City of Fredericksburg

Planning and Zoning Meeting Agenda
Wednesday, August 7, 2024 ~ 5:30 PM
Law Enforcement Center
1601 E. Main Street
Fredericksburg, Texas 78624

- A. Consider P-2415 - Review of a Preliminary Plat for the Sonoma Oaks Subdivision Located at 112 Hollmig Lane.

- B. Consider P-2416 - Review of a Final Plat for the Chick-Fil-A Subdivision Located on the South East Corner of HWY 87 and Friendship Lane.
- C. Consider SP-2407 - Review of a Site Plan and Entry Corridor for a Hotel Development Located at 620 E San Antonio

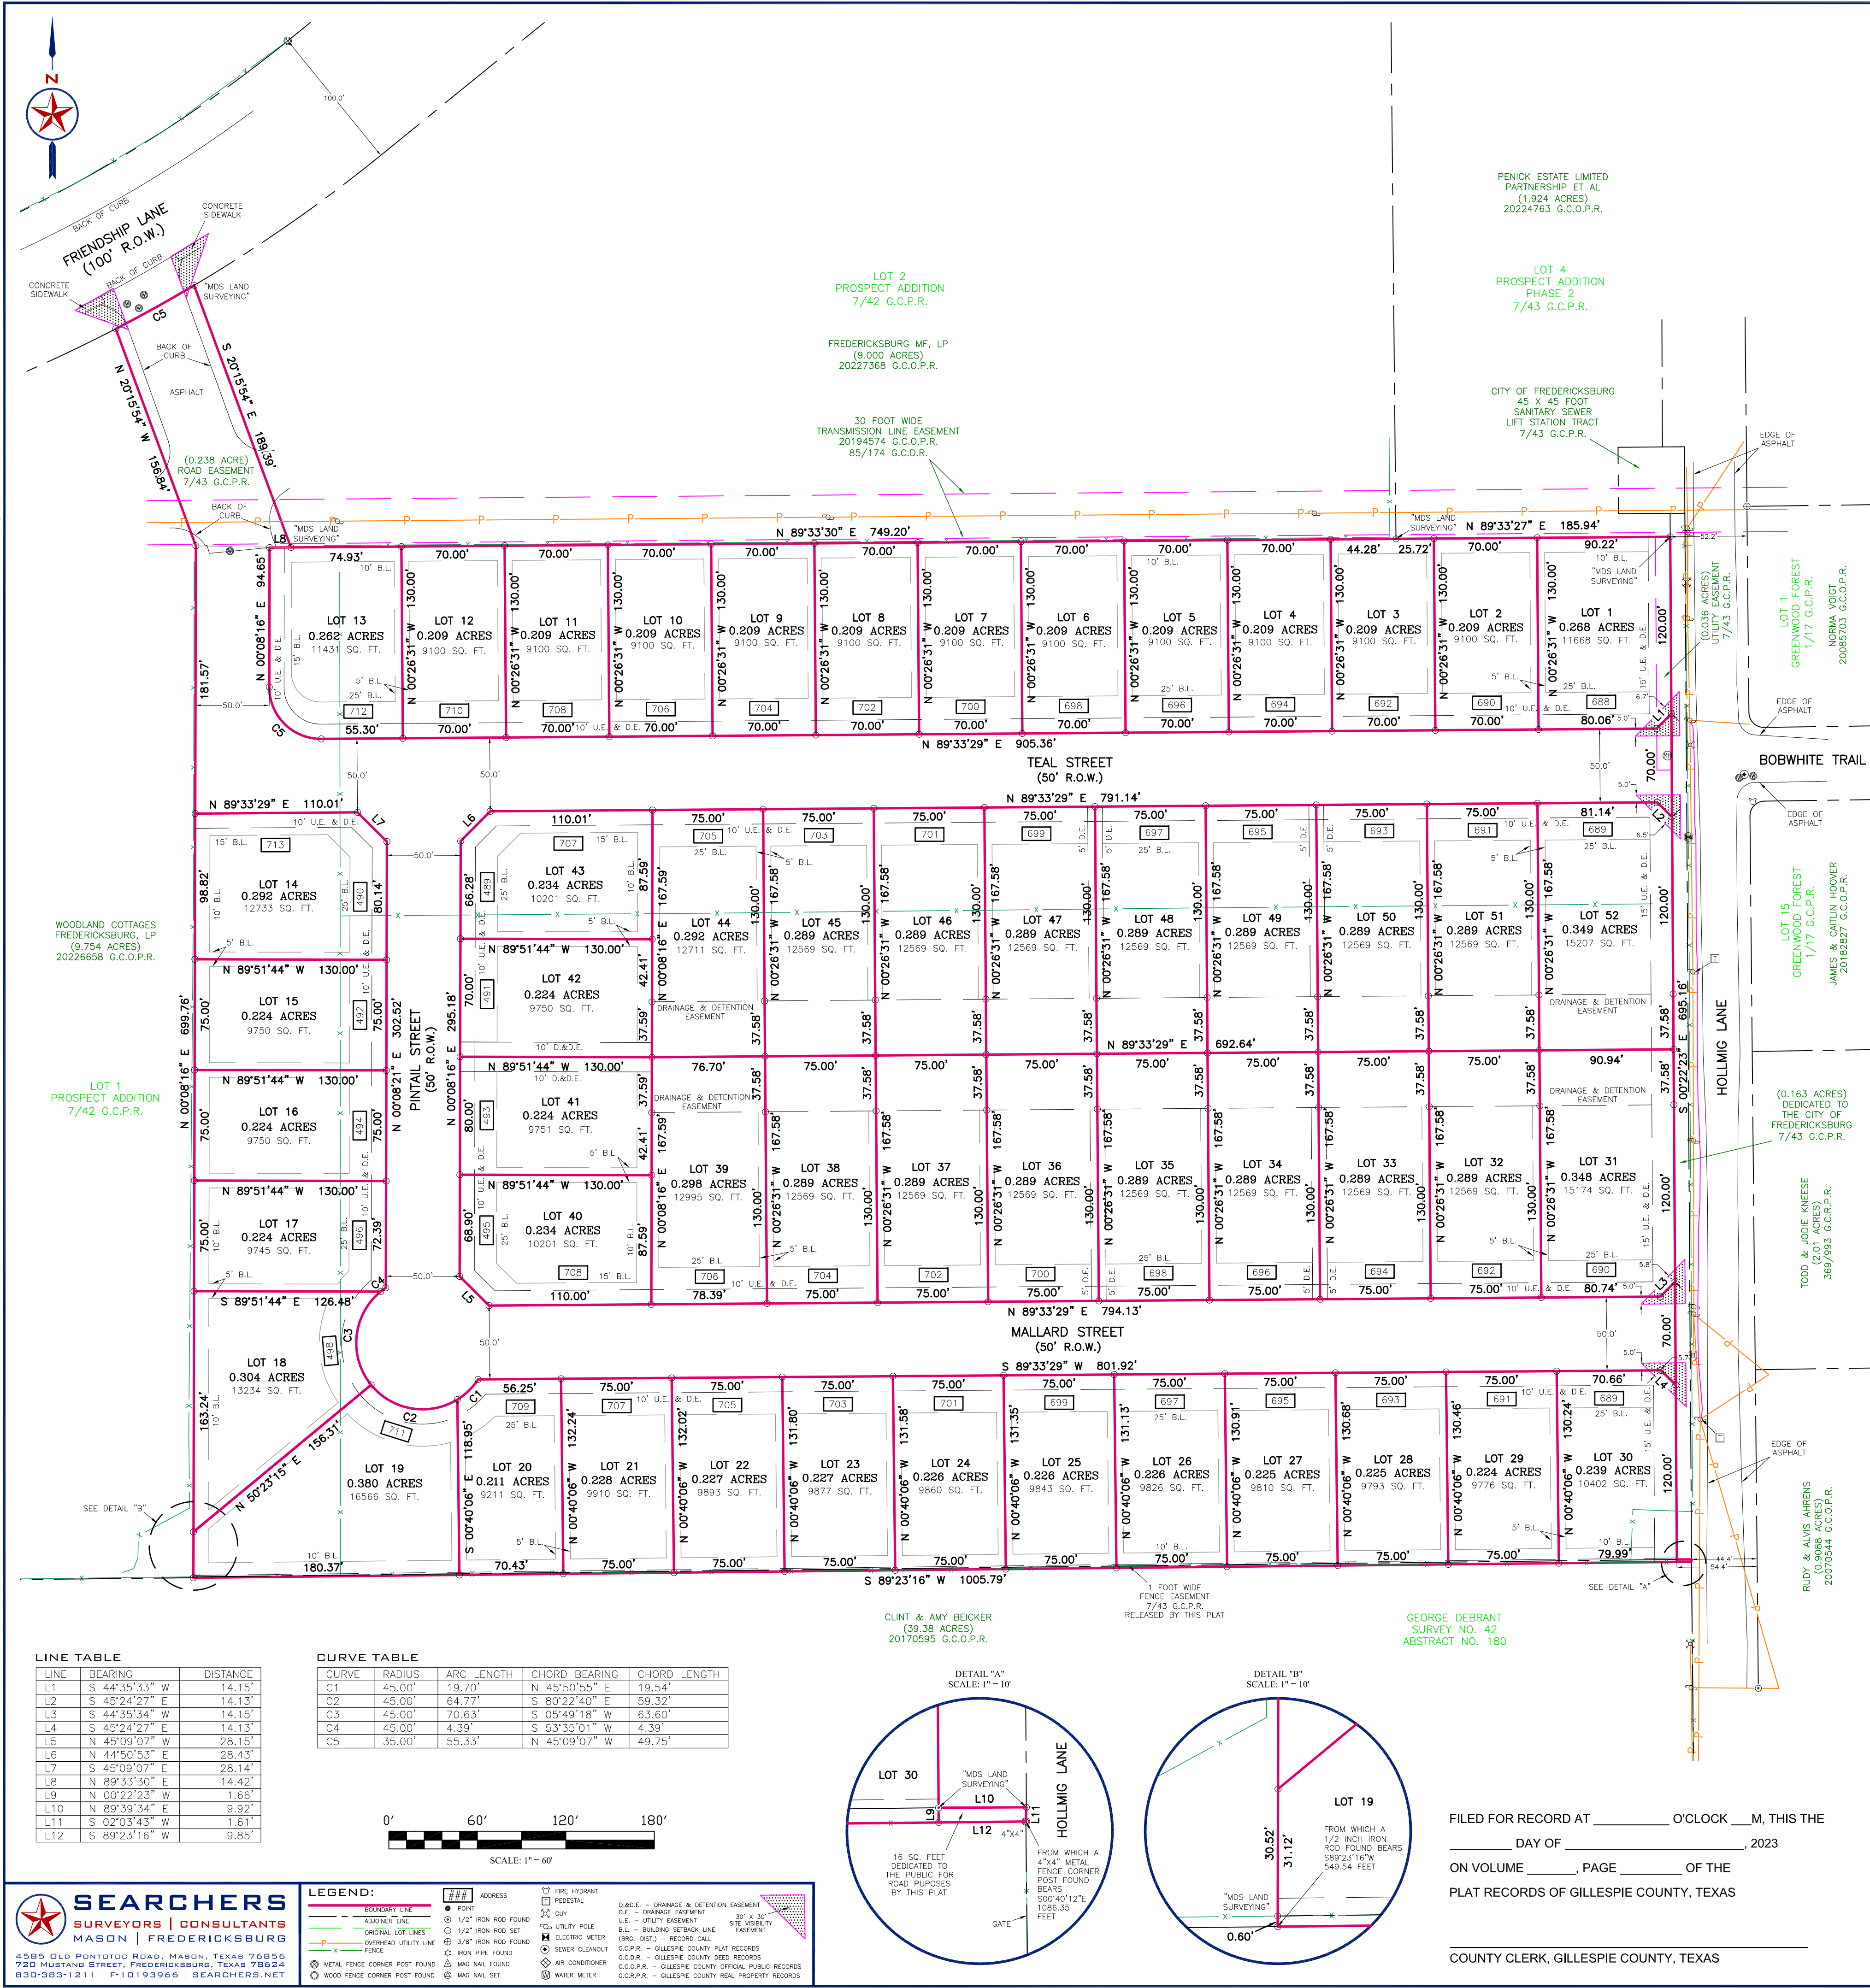
- The Preliminary Plat will require Planning and Zoning Approval tentatively scheduled for Wednesday, August 7, 2024.
- Add Project Number, P-2415, to Plat.
- Project will require Final Plat approval [Sec. 4.05 – Subdivision Ordinance](#)
- A Parkland dedication fee of \$500.00 per lot for a total of \$26,500.00 must be paid prior to recordation of the Final Plat. [Sec. 6.15 – Subdivision Ordinance.](#)
- The Comprehensive Plan calls for neighborhood placemaking elements that add Community character and support pride of ownerships. Examples are sidewalks, pocket parks and street trees. [Action N.1.A.6 – Comprehensive Plan](#) [Sec. 4.4.G.7 – Subdivision Ordinance](#)

The Comprehensive Plan calls for a connected network of sidewalks, paths and/or bike routes within neighborhoods and connecting to nearby collector and arterial streets.

- Please provide 3 street names. Bobwhite Loop is not an acceptable street name. The Street to the North may be West Bobwhite Trail.

- Please show the connection to Friendship Lane

- Plans will not be reviewed or considered without a response sheet. **Acknowledged.**
- The Preliminary Plat will require Planning and Zoning Approval tentatively scheduled for Wednesday, August 7, 2024. **Acknowledged.**
- Add Project Number, P-2415, to Plat. **Acknowledged.**
- Project will require Final Plat approval Sec. 4.05 – Subdivision Ordinance. **Acknowledged.**
- A Parkland dedication fee of \$500.00 per lot for a total of \$26,500.00 must be paid prior to recordation of the Final Plat. Sec. 6.15 – Subdivision Ordinance. **Acknowledged.**
- The Comprehensive Plan calls for neighborhood placemaking elements that add Community character and support pride of ownerships. Examples are sidewalks, pocket parks and street trees. The drainage and detention easement will provide additional green space. A sidewalk has been added to connect to Friendship Lane sidewalk system.

The Comprehensive Plan calls for a connected network of sidewalks, paths and/or bike routes within neighborhoods and connecting to nearby collector and arterial streets. Action M.1.B.1 – Comprehensive Plan Sec. 4.4.G.7 – Subdivision Ordinance . **The existing Hollmig road is a county road section with approximately 20 feet of pavement that will continue north of this subdivision. In order to provide a safer route to Friendship Lane, the nearby arterial street, we are proposing a sidewalk extension between the subdivision to Friendship Lane. This short segment will have “no parking” and be 36’ wide where new and tie into the existing pavement which is a secondary access to the multifamily properties. The entire road will be dedicated to the City. The remaining streets within the neighborhood will follow the city standard street sections.**

- Please provide 3 street names. Bobwhite Loop is not an acceptable street name. The Street to the North may be West Bobwhite Trail. **Street names have been added to the preliminary plat document and have been tentatively approved by Gillespie County addressing. We believe there is some clarity that needs to occur on short segments.**
- Please update addressing accordingly based on the new street name configuration. **Acknowledged.**
- D107.1 One- or two-family dwelling residential developments. Developments of one- or two-family dwellings where the number of *dwelling units* exceeds 30 shall be provided with two separate and *approved* fire apparatus access roads. **An additional street section direct to Friendship Lane has**

been added to the preliminary plat to provide 3 access points to 2 different roads from the Subdivision.

- Please show the connection to Friendship Lane. **A connection to Friendship Lane is provided.**

AS REPLATTED

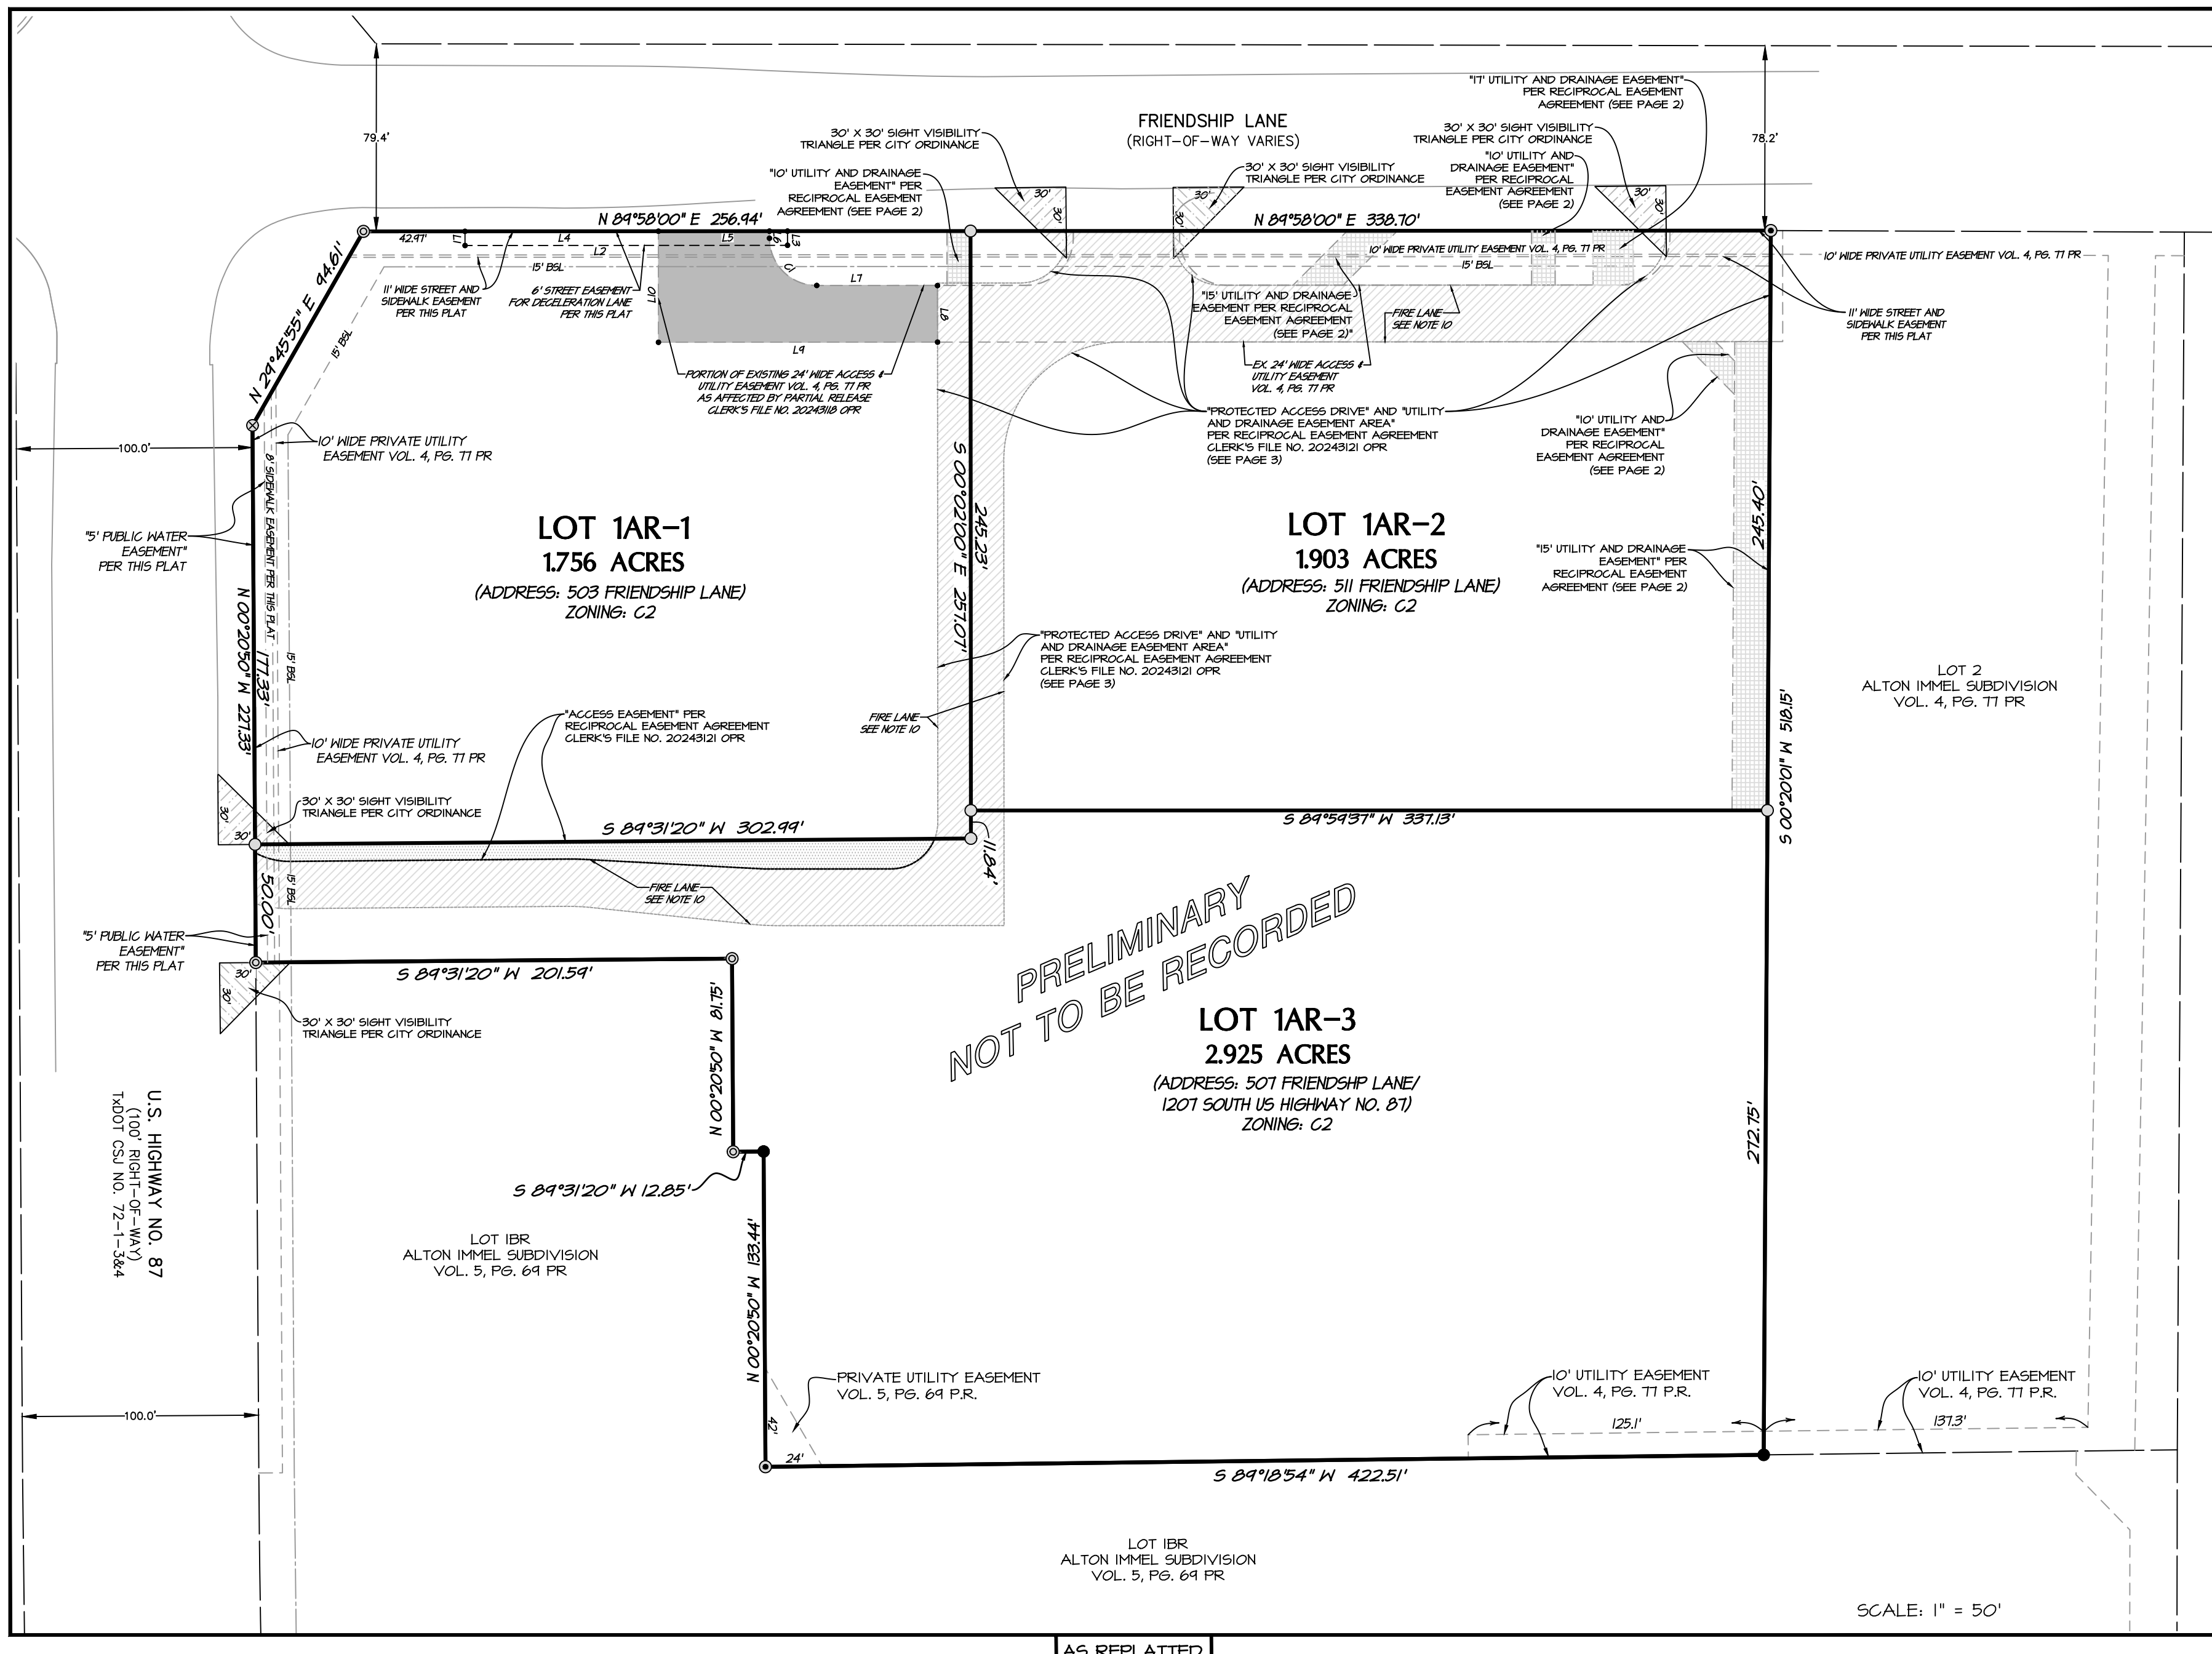
- The Preliminary Plat will require Planning and Zoning Approval tentatively scheduled for Wednesday, August 7, 2024.
- Remove project number P-2330 and add project number, P-2416, to Plat.
- A Parkland dedication fee of \$500.00 per lot for a total of \$1,500.00 must be paid prior to recordation of the Final Plat. [Sec. 6.15 – Subdivision Ordinance.](#)
- Provide a title search for the three lots.
- Update the Certificate of Final Plat Approval to reflect the signature block found in [Sec. 4.05.M.5 – Subdivision Ordinance](#)

- Recordation of final plat to be after acceptance of public improvements.
- Show document numbers for separate instruments.
- Provide reciprocal easement agreements.
- Add note stating that all utility and drainage easements internal to the site and serving these lots are private.
- Add a note stating that the developer is responsible for maintenance.

Comment 1: The Preliminary Plat will require Planning and Zoning Approval tentatively scheduled for Wednesday, August 7, 2024.

Response: Noted. Thank you

Comment 2: Remove project number P-2330 and add project number, P-2416, to Plat.

Response: Revised on plat

Comment 3: A Parkland dedication fee of \$500.00 per lot for a total of \$1,500.00 must be paid prior to recordation of the Final Plat. Sec. 6.15 – Subdivision Ordinance.

Response: Understood

Comment 4: Provide a title search for the three lots.

Response: We have attached with our submittal.

Comment 5: Update the Certificate of Final Plat Approval to reflect the signature block found in Sec. 4.05.M.5 – Subdivision Ordinance

Response: Revised on plat

Comment 6: Recordation of final plat to be after acceptance of public improvements.

Response: Understood.

Comment 7: Show document numbers for separate instruments.

Response: Shown on plat

Comment 8: Provide reciprocal easement agreements.

Response: We have attached with our submittal.

Comment 9: Add note stating that all utility and drainage easements internal to the site and serving these lots are private.

Response: Added on plat under general notes.

Comment 10: Add a note stating that the developer is responsible for maintenance.

Response: Added on plat under general notes.
